UNITED STATES PATENT AND TRADEMARK OFFICE

Office Action Summary	Application No. 10/552,532	Applicant(s) HAYASHI, YASUSHI	
	Examiner AMENE S. BAYOU	Art Unit 3746

DETAILED ACTION

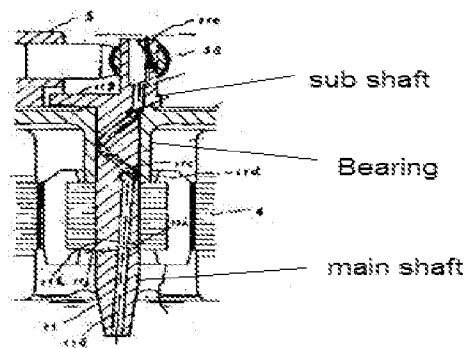
- **Electric compressor ,in figure 1 and 2 ,comprising :a single phase induction motor (4)** formed of stator and rotor
- **A compressing mechanism (5)** driven by the **motor (4)**
- **A hermetic container (2)** for accommodating the motor (4) and the compressing mechanism (2) and for pooling **lubricant (7)**
- A shaft having a main shaft and sub shaft (shown below)

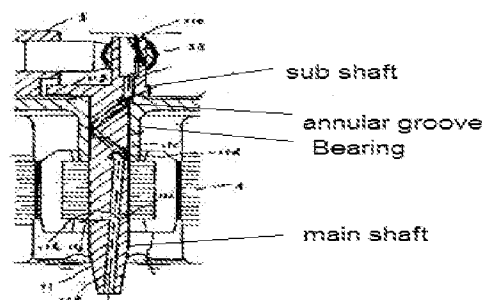
- A **cylinder (5)** for forming a compressing chamber
- A bearing (shown below) for supporting the main shaft

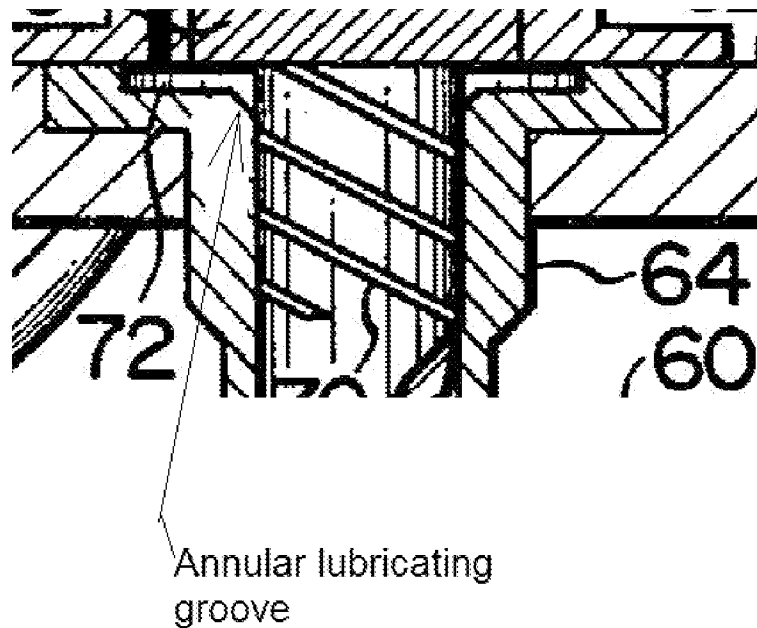
- A **centrifugal pump (11)** opening into the **lubricant (7)**
- A **forward leading groove (11c)** engraved on an outer wall of the main shaft and having a first end communicating with the centrifugal pump (11a).

- A **vertical hole (11f)** bored in the sub shaft and having a first end communicating with the annular lubricant groove and a second end opening into the hermetic container .Nobuo et al.,however fail to disclose the following limitation which is taught by Goodnight:

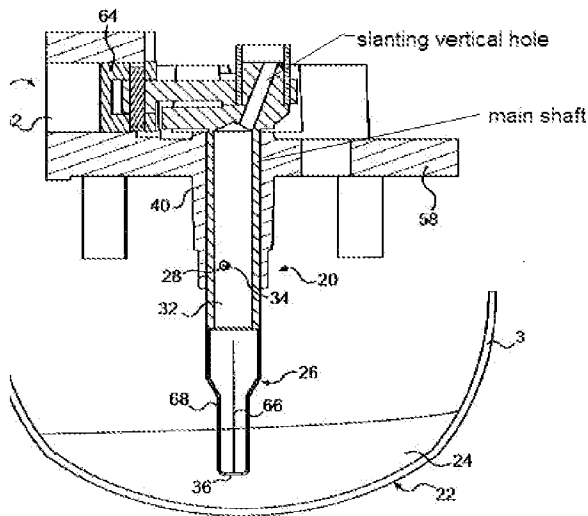
Goodnight discloses:

- Lead of the reverse leading groove is greater than that of the forward leading groove in **column 7, lines 10-11 and line 35-38.**
